SEWAGE DISPOSAL SYSTEM

HOWARD COUNTY HEALTH DEPARTMENT

PERC TEST PLAT
LOT 12
PHEASANT LANDING
FIFTH ELECTION DISTRICT
HOWARD COUNTY, MARYLAND
Plat No.

SITE PLAN
 LOT 12
PHEASANT LANDING
 (C.M.P. 6566)
 5TH ELECTION DIST. HO. CO. MD.
 SCALE: 1" = 50' AUG. 8, 1986
Paradise Builders

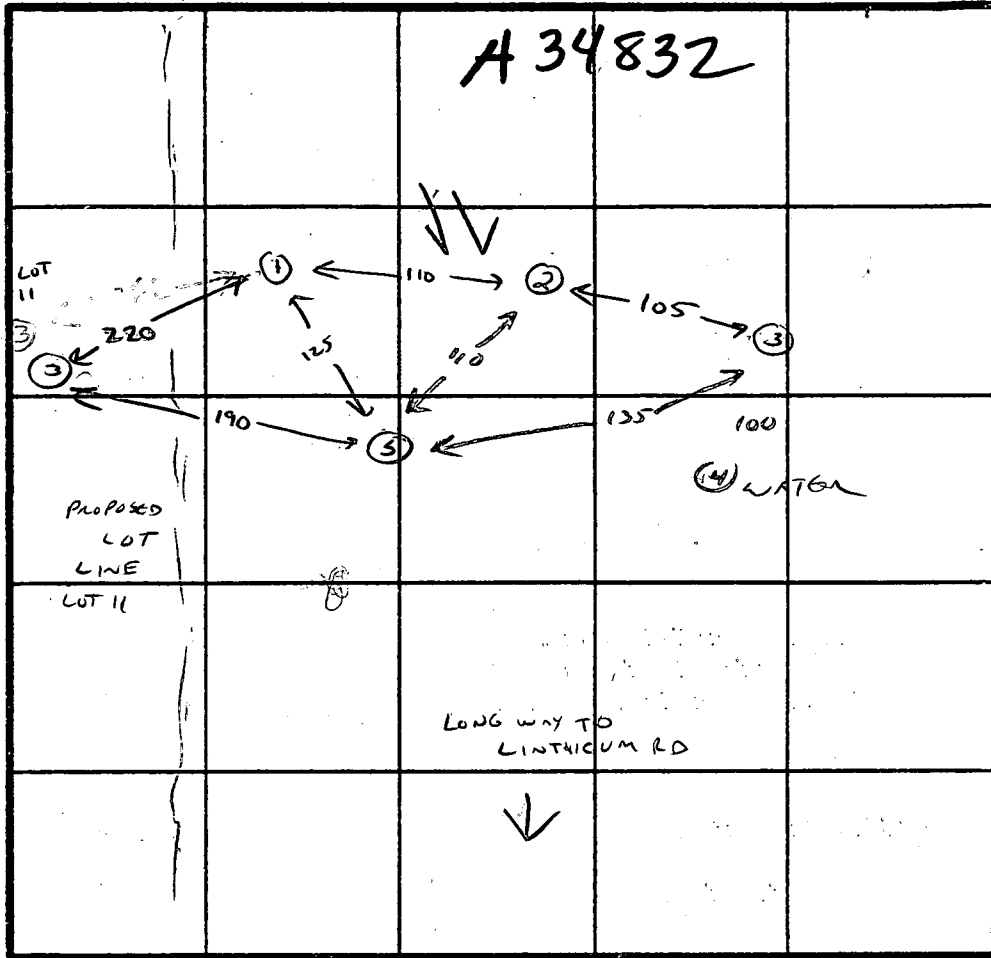
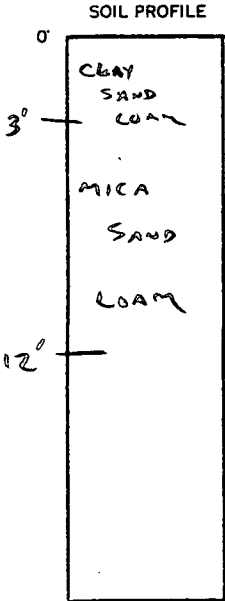
HOLD PENDING FURTHER TESTS C.W. - REDESIGN REQUIRED DATE 1/25/85

REASONS FOR REJECTION OR HOLDING CERTIFIC. PLAT/SUBDIVISION PLAT REQ'D.

PLAT REVIEW INDICATES INCORRECT PERC FIELD - ADJUSTMENT REQ'D.
(LOT LISTED AS NON-BUILDABLE AT THIS T.O.G. 1/23/86 CW) 4/14/85 CW

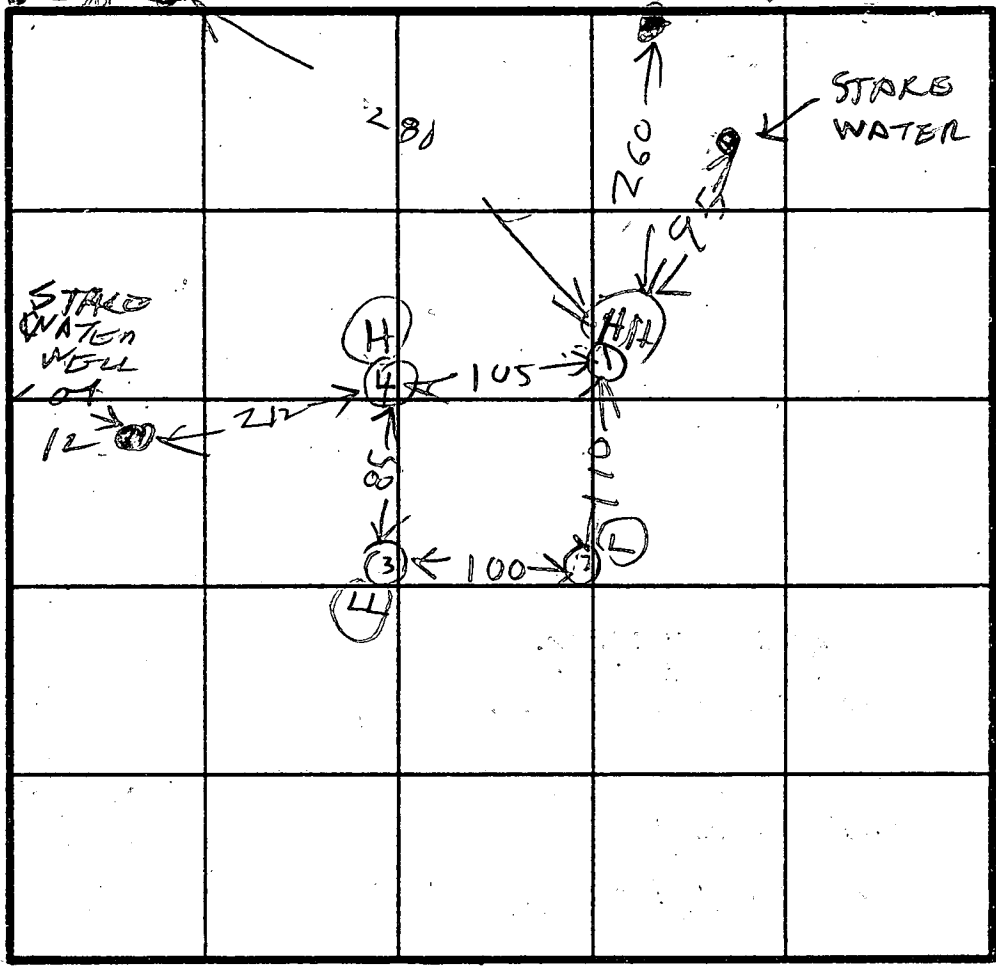
2/18/86 PERC HOLE (4) IS 4' 4" FROM EXISTING WELL LOT 11

REMARKS Possibly has an owner must check with Engineer

2/18/86 office study indicates holes dug on wrong lot PH & field measurements have 2 holes wrong lot

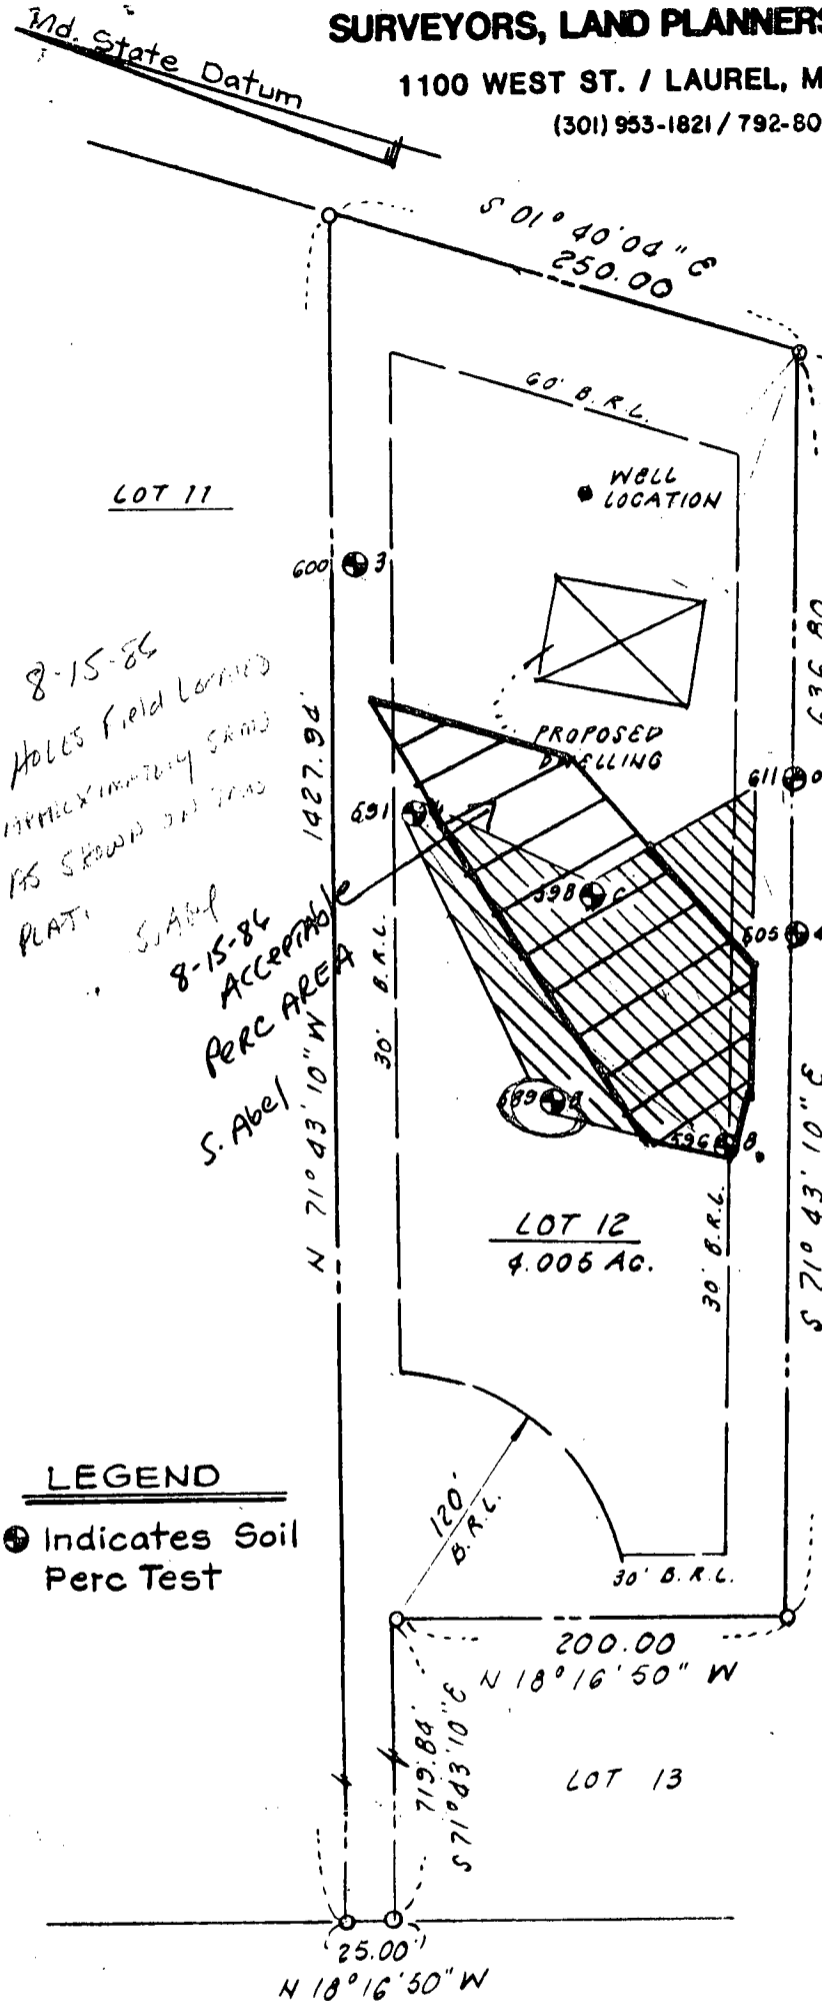
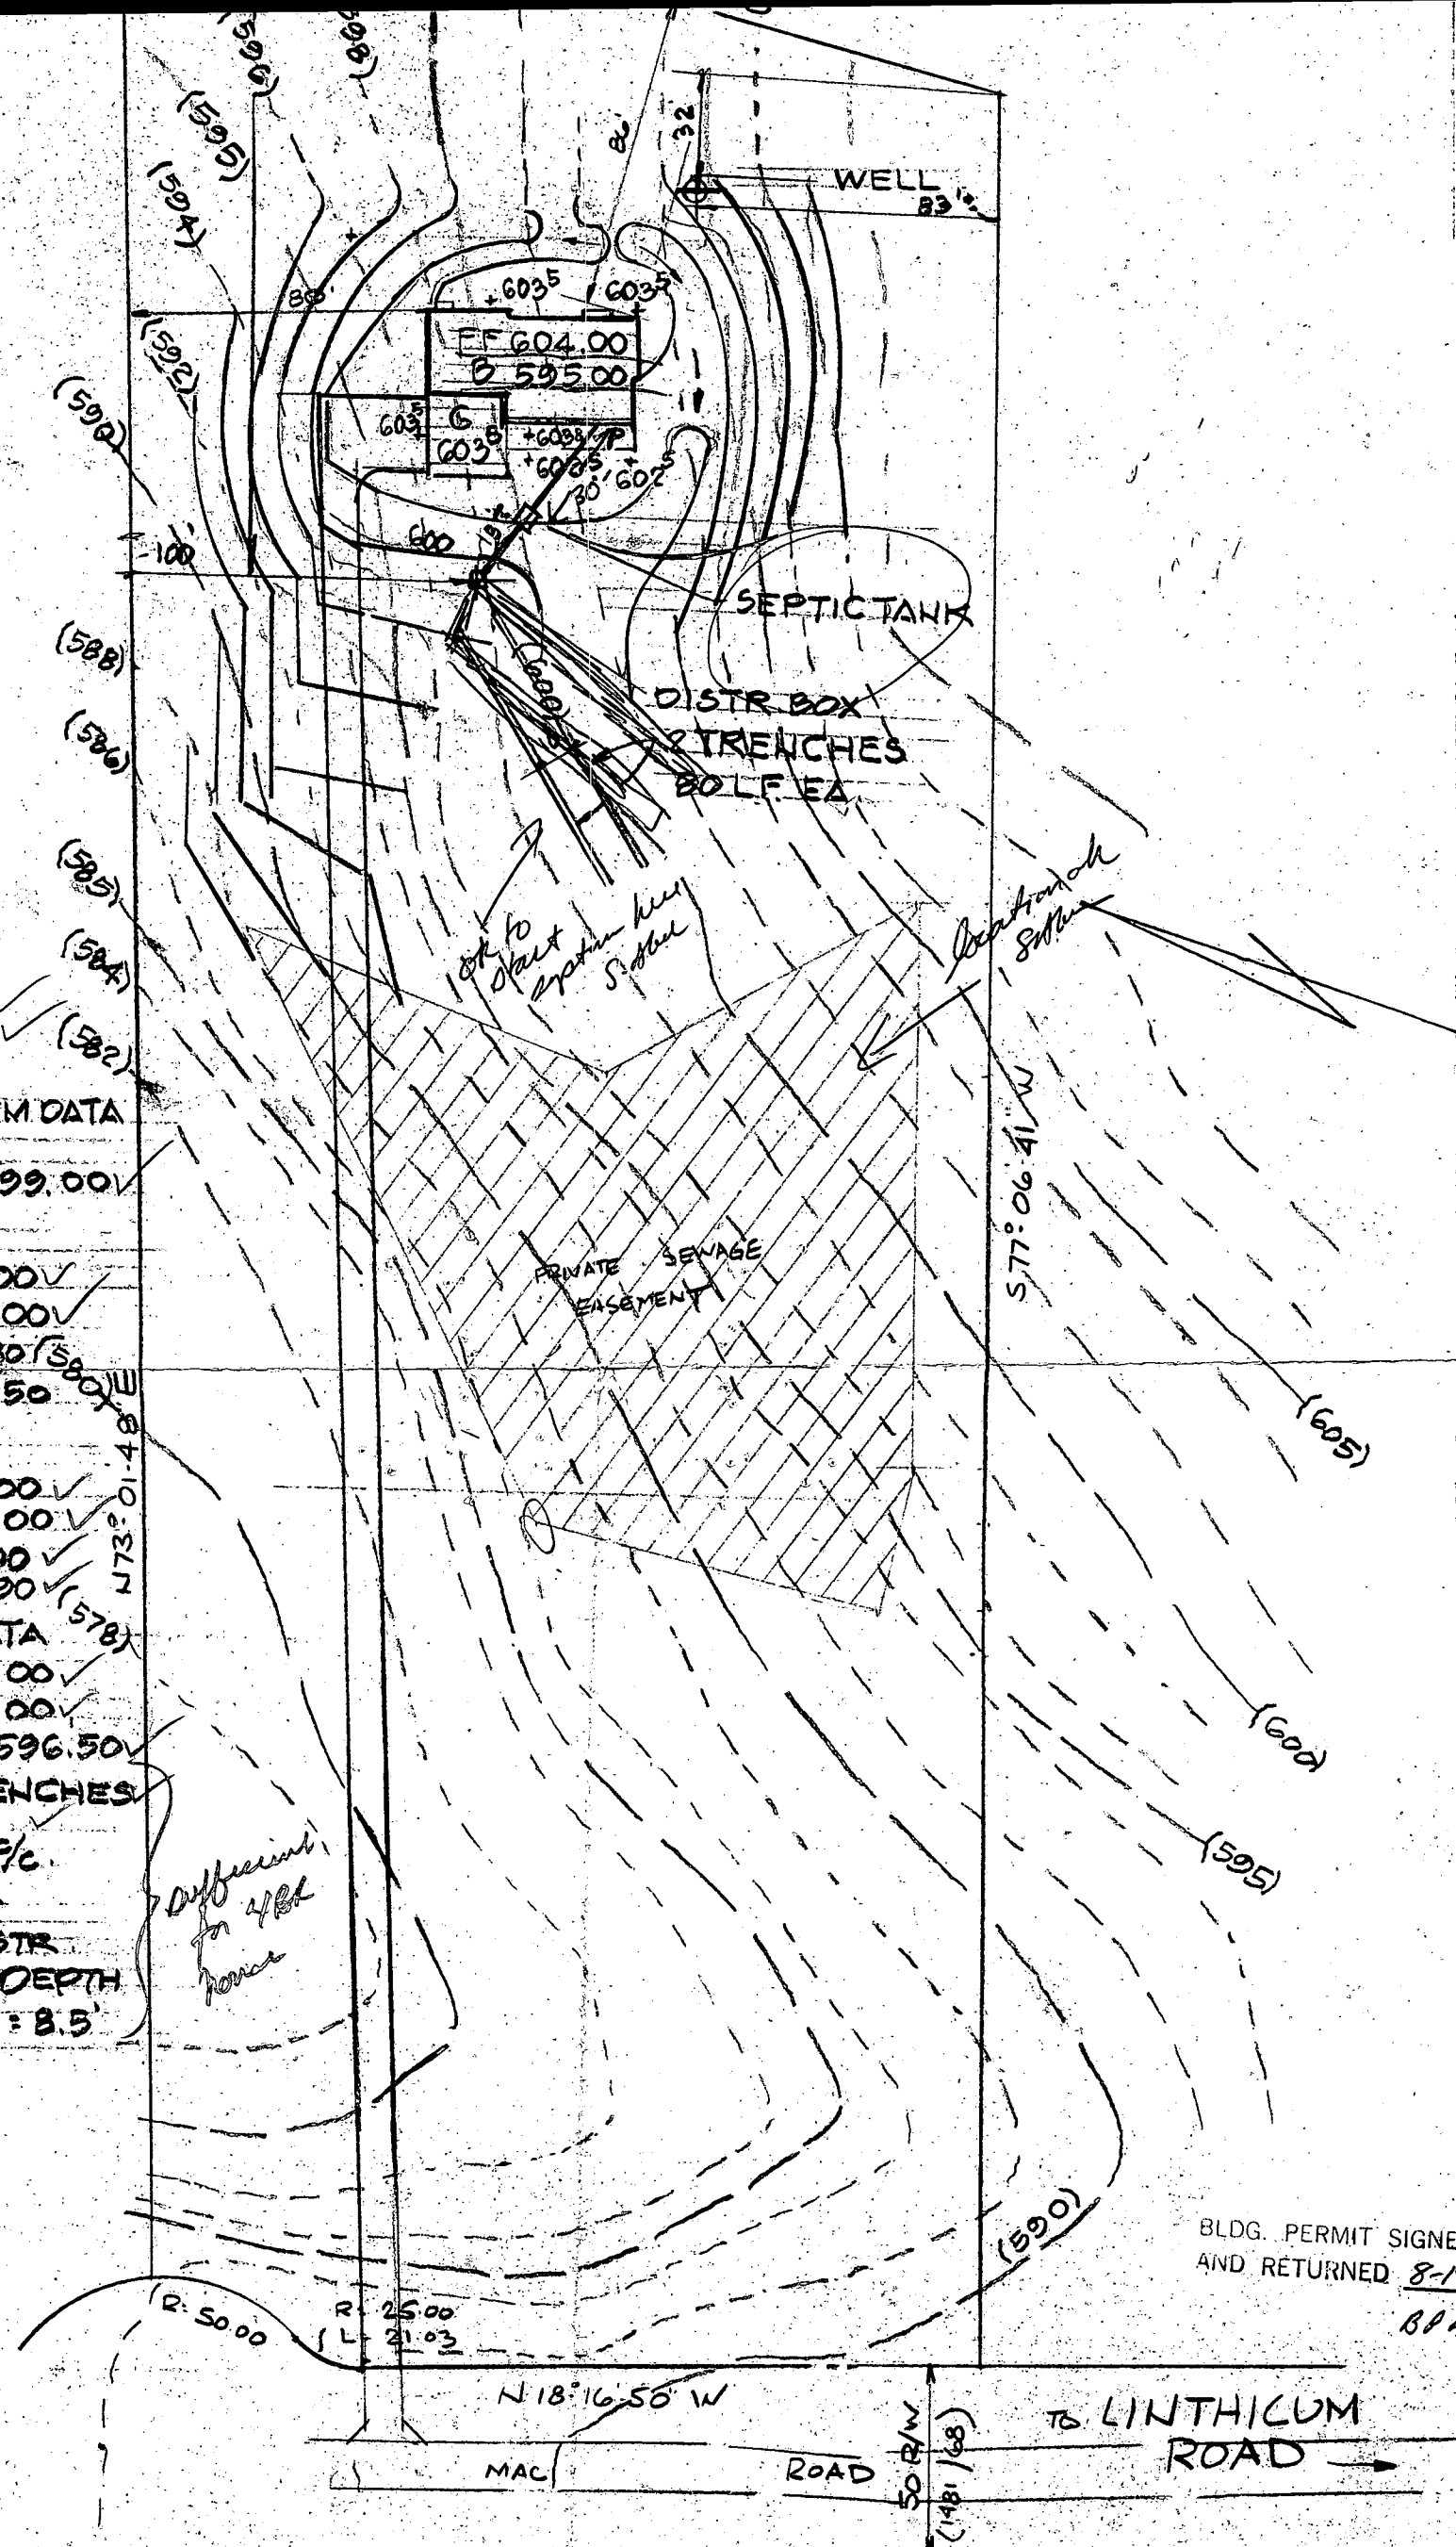
*8-15-86
Copy sent to
Fiddle for
connection of
perc filed
S. Abel*

*8-15-86
HOLLES Field Located
APPROXIMATELY SHOWN
AS SHOWN ON THIS
PLAT.
S. Abel
8-15-86
ACCEPTABLE
PERC AREA*

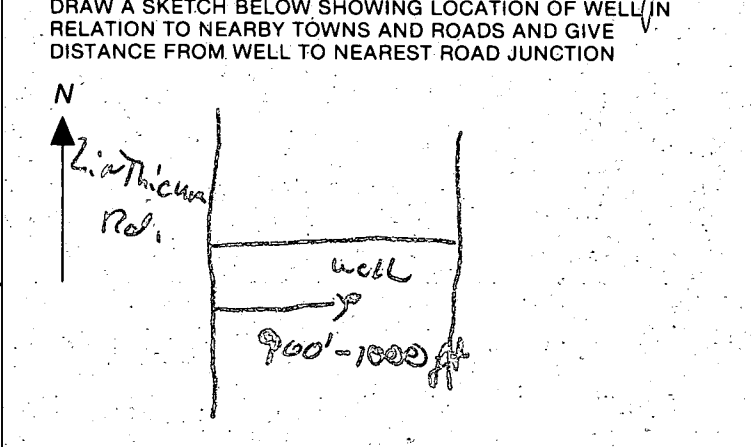
Confirmed w/
 John Mellema
 will send
 revised
 copy.
 Elevations
 ok
 S. Allen
 8/14/86
